**MARALEX RESOURCES INC**  
**SOUTH SHALE RIDGE-68S98W 24SWNE**  
**Location # 312609**

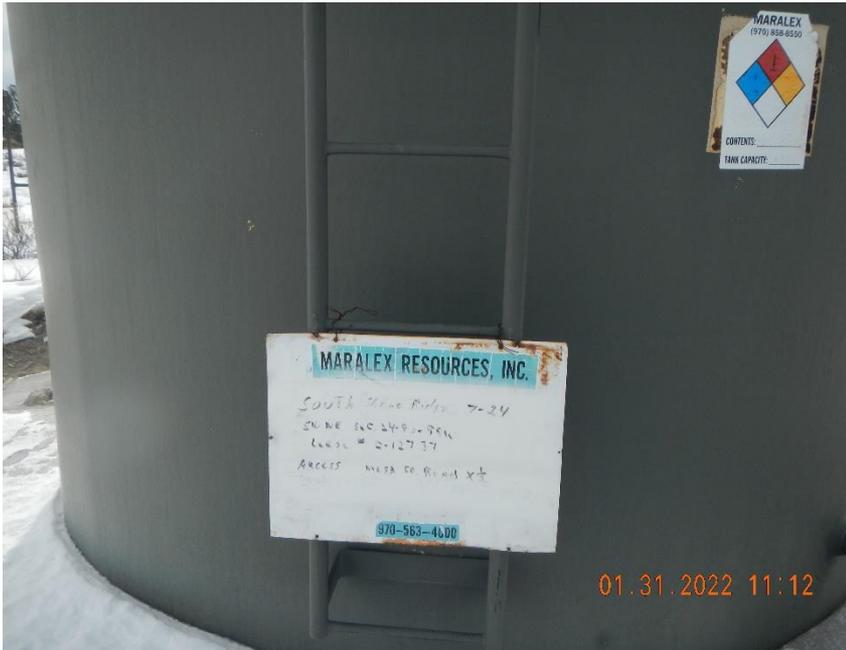
**EMS (911) not posted on battery sign.**  
**Tank battery sign is illegible and does not meet Rule 605.e.**
